PROPOSED RESIDENTIAL DEVELOPMENT
59 CUDGEGONG ROAD ROUSE HILL, NSW 2155

SITE 1

DEVELOPMENT APPLICATION

BASEMENT PLAN LVL-2

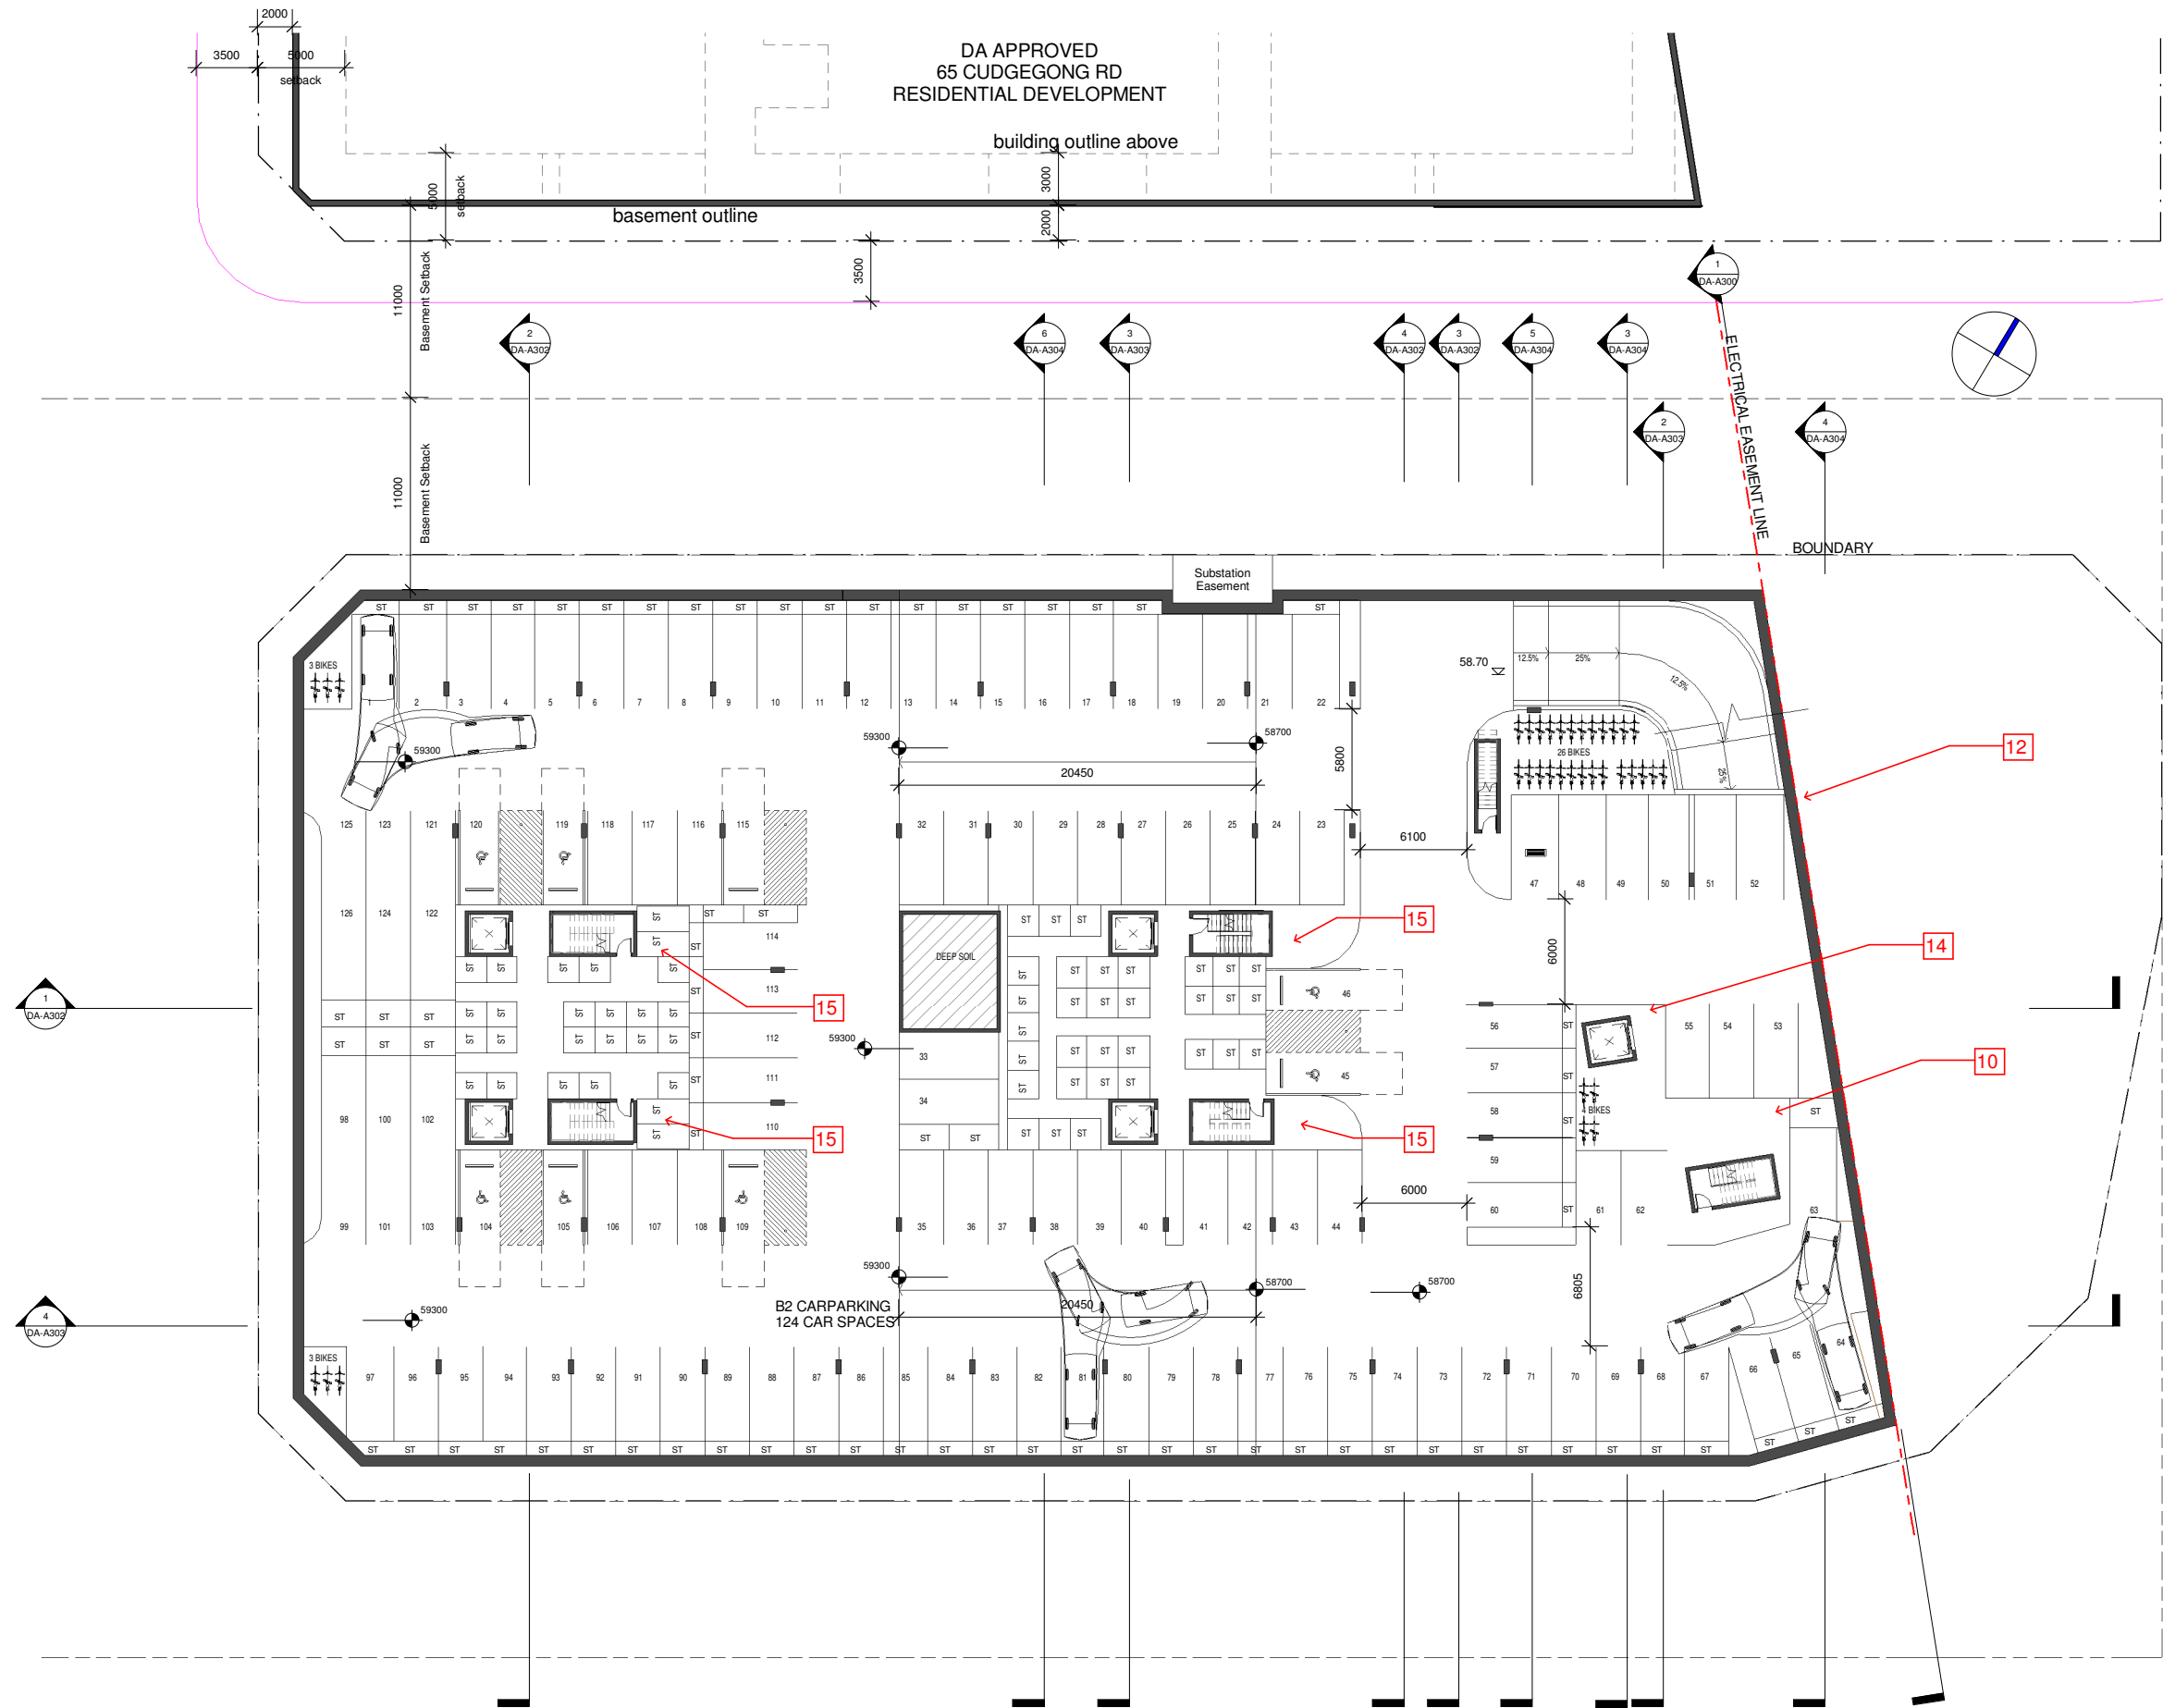
- Notes:
1. Bin travel path with 1.5m wide provided at basement.
 2. Removable bollards and a no parking line mark noted.
 3. Truck sweep paths of 11.00m long council truck provided.

4. Building-A residents access to recycling bins located at the top of the stair well and adjacent to the lift core from Level 1 and above added.
 5. Waste room access adjacent to the driveway ramp relocated.

6. 1.5m wide doorway provided in each bulky waste storage areas and caged enclosure.
 7. Driveway ramp gradients adjusted.
 8. 240L recycling bins provided

9. Access between bulky goods and waste bin room deleted.
 10. Fire stair relocated
 11. Lift relocated and Waste room and bulky storage adjusted.
 12. Relocate lift, fire stair adjusted and relayout of car and bicycle parkings.

13. Waste room and bulky storage adjusted.
 14. Relocated lift core and car and bicycle parking adjusted.
 15. Fire stairs adjusted and relocated door access openings.

16. Redesigned Building A to achieved solar access requirements to the communal open space. Fire stairs and lift relocated, access ramp added to access COS and redesigned of the unit layouts.

17. Redesigned of unit layout A61,A65,A69,A73,A77,A81,A85,A92,A96,A100,A104,A108,A112 and A116.
 18. Redesigned of unit layout B06,B10,B14,B18,B22,B26,B30,B41,B45,B49,B53,B57 and B61.

19. Building A roof plan adjusted and roof overhang deleted.
 20. Skylights provided on Unit A45,A76,A77,B30& B31 but is not included in the solar calculation that recieved minimum 2hrs of sunlight.

21. Adjusted unit layout B36,B40,B44,B48,B52,B56, and B60
 22. Adjusted layout-bulk storage and waste room
 23. Adjusted bin layout

SHEET TITLE:
LEVEL 1
DESIGN:
NS
DRAWN:
AJRSA
DATE:
JUNE 2016
SCALE:
AS SHOWN

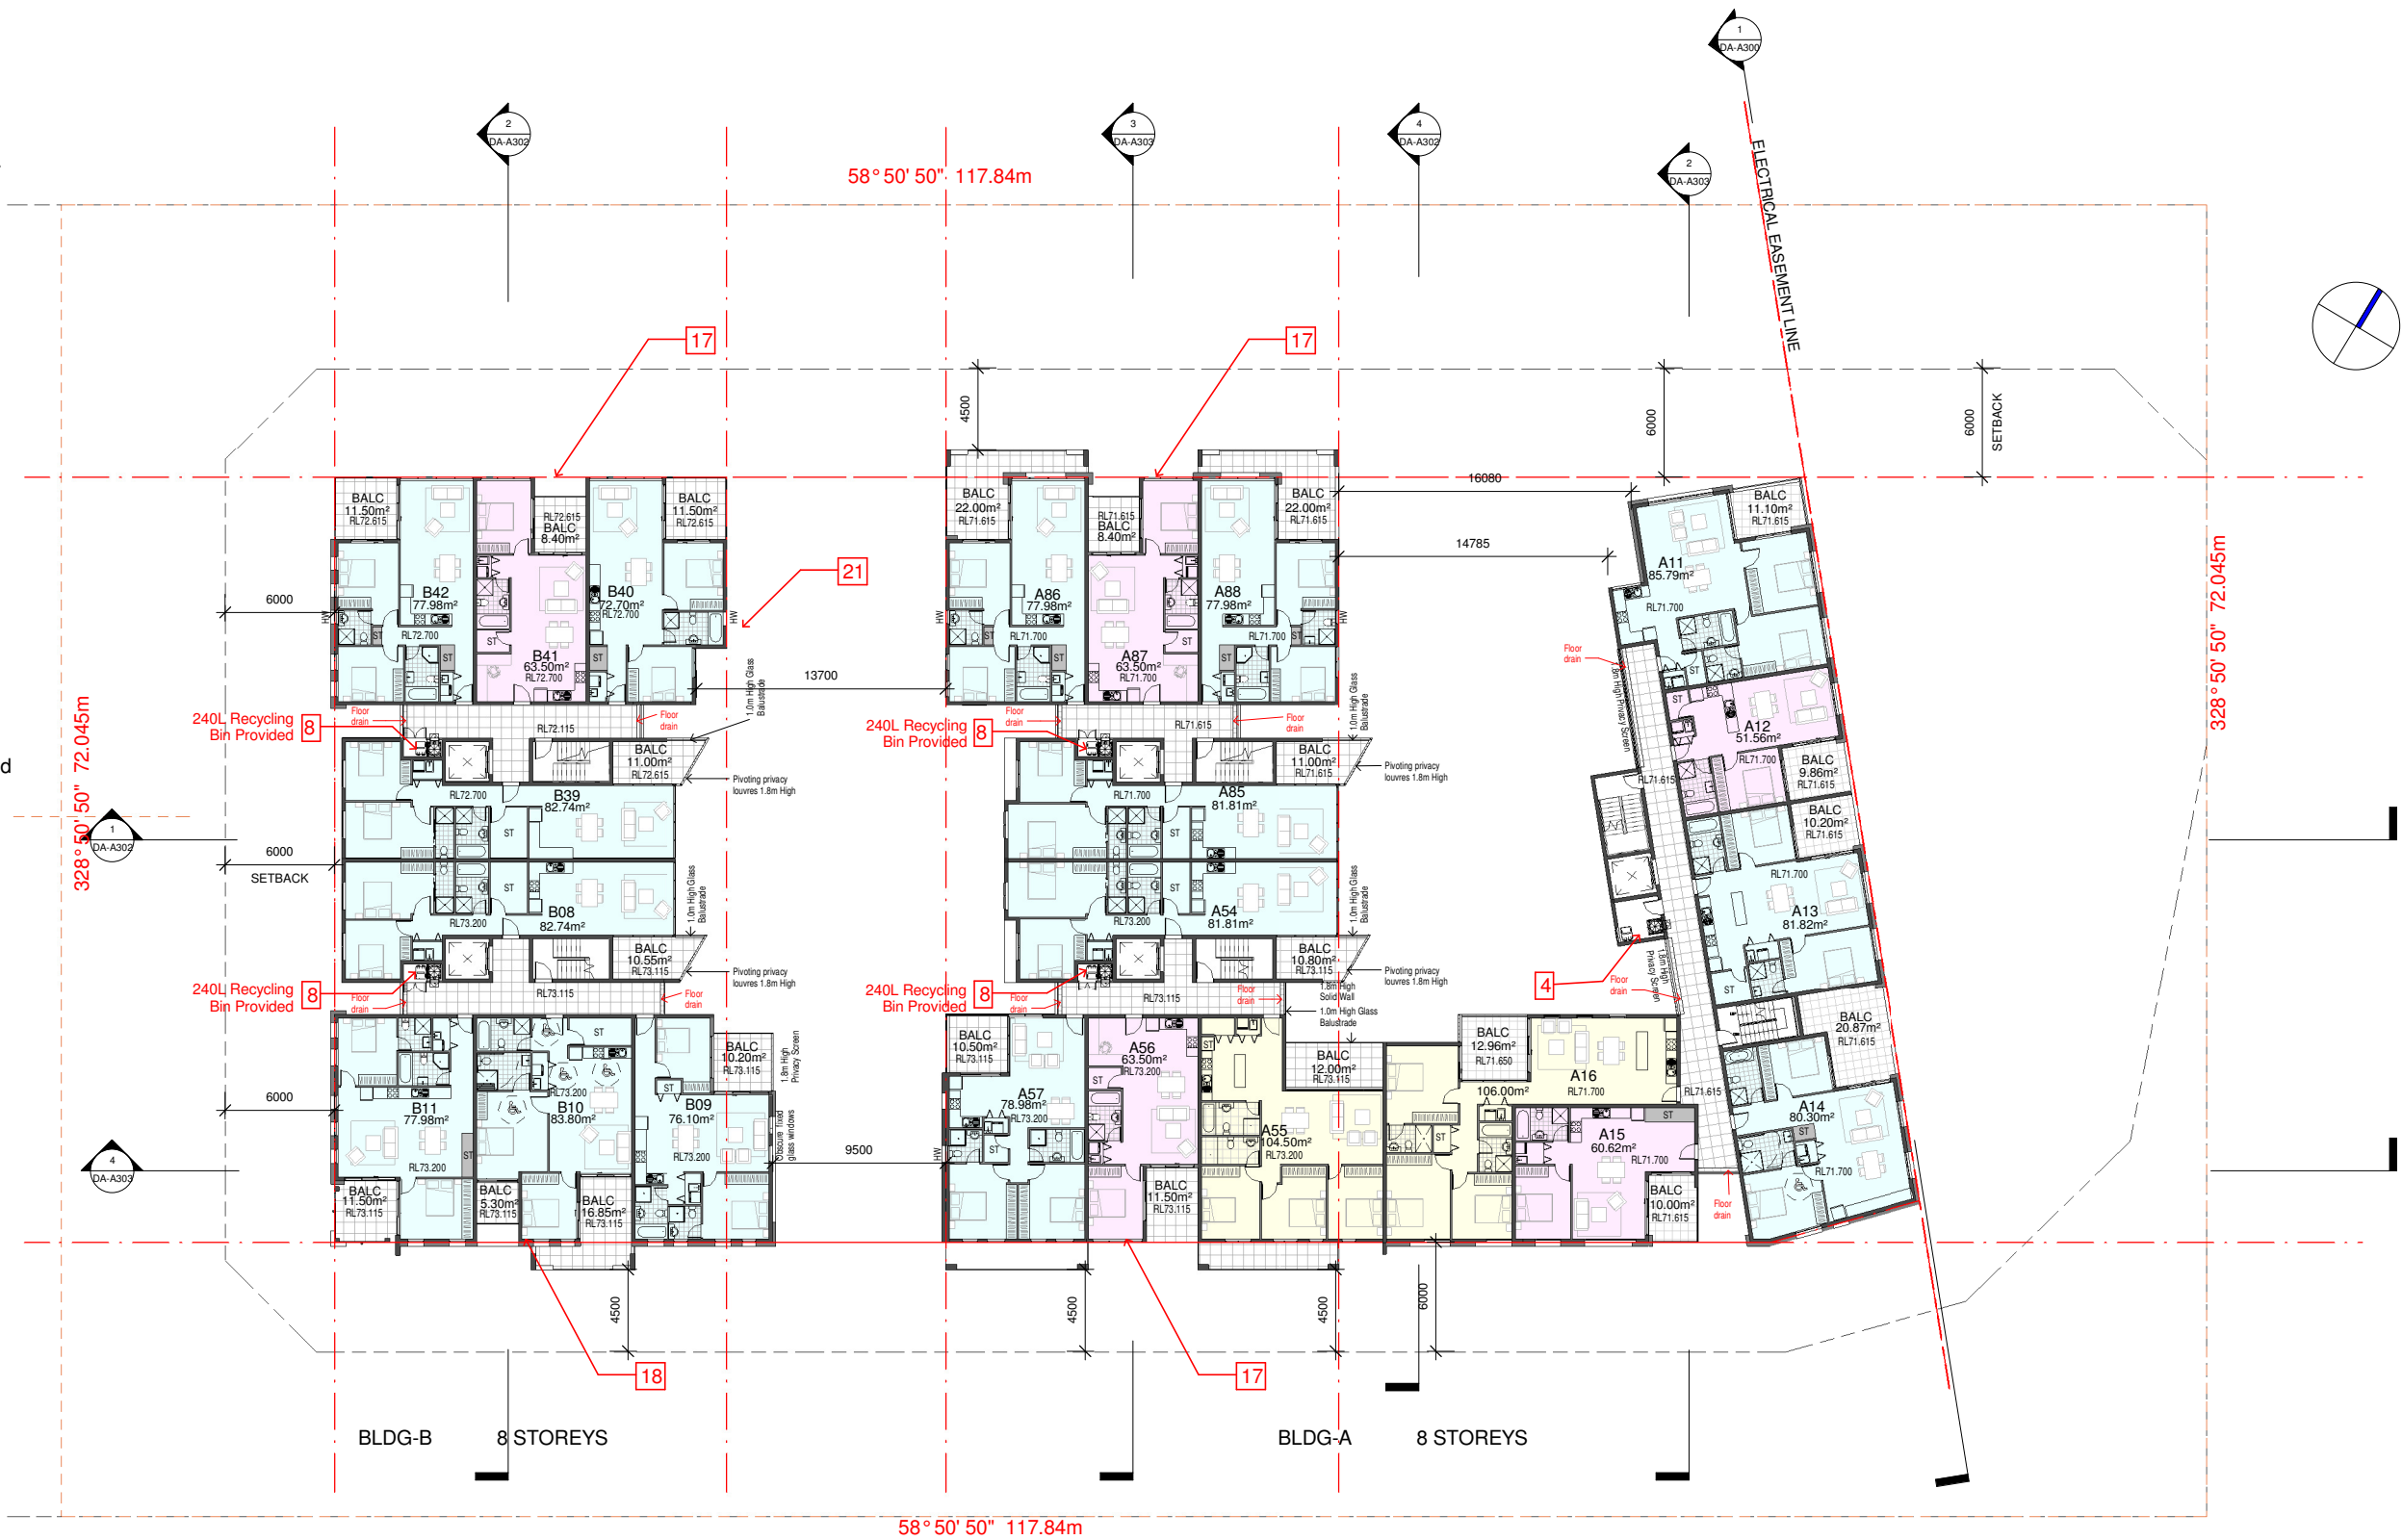
1. Bin travel path with 1.5m wide provided at basement.
- 2.Removable bollards and a no parking line mark noted.
- 3.Truck sweep paths of 11.00m long council truck provided.

- 4.Building-A residents access to recycling bins located at the top of the stair well and adjacent to the lift core from Level 1 and above added.
- 5.Waste room access adjacent to the driveway ramp relocated.

- 6.1.5m wide doorway provided in each bulky waste storage areas and caged enclosure.
7. Driveway ramp gradients adjusted.
8. 240L recycling bins provided

- 9.Access between bulky goods and waste bin room deleted.
10. Fire stair relocated
- 11.Lift relocated and Waste room and bulky storage adjusted.
- 12.Relocate lift, fire stair adjusted and relayout of car and bicycle parkings.

- 13.Waste room and bulky storage adjusted.
- 14.Relocated lift core and car and bicycle parking adjusted.
- 15.Fire stairs adjusted and relocated door access openings.

- 16.Redesigned Building A to achieved solar access requirements to the communal open space. Fire stairs and lift relocated,access ramp added to access COS and redesigned of the unit layouts.

17. Redesigned of unit layout
A61,A65,A69,A73,A77,A81,A85,A92,A96,A100,A104,A108,A112 and A116.
- 18.Redesigned of unit layout
B06,B10,B14,B18,B22,B26,B30,B41,B45,B49,B53,B57 and B61.

- 19.Building A roof plan adjusted and roof overhang deleted.
- 20.Skylights provided on Unit A45,A76,A77,B30& B31 but is not included in the solar calculation that recieved minimum 2hrs of sunlight.

- 21.Adjusted unit layout
B36,B40,B44,B48,B52,B56,and B60
22. Adjusted layout-bulk storage and waste room
23. Adjusted bin layout
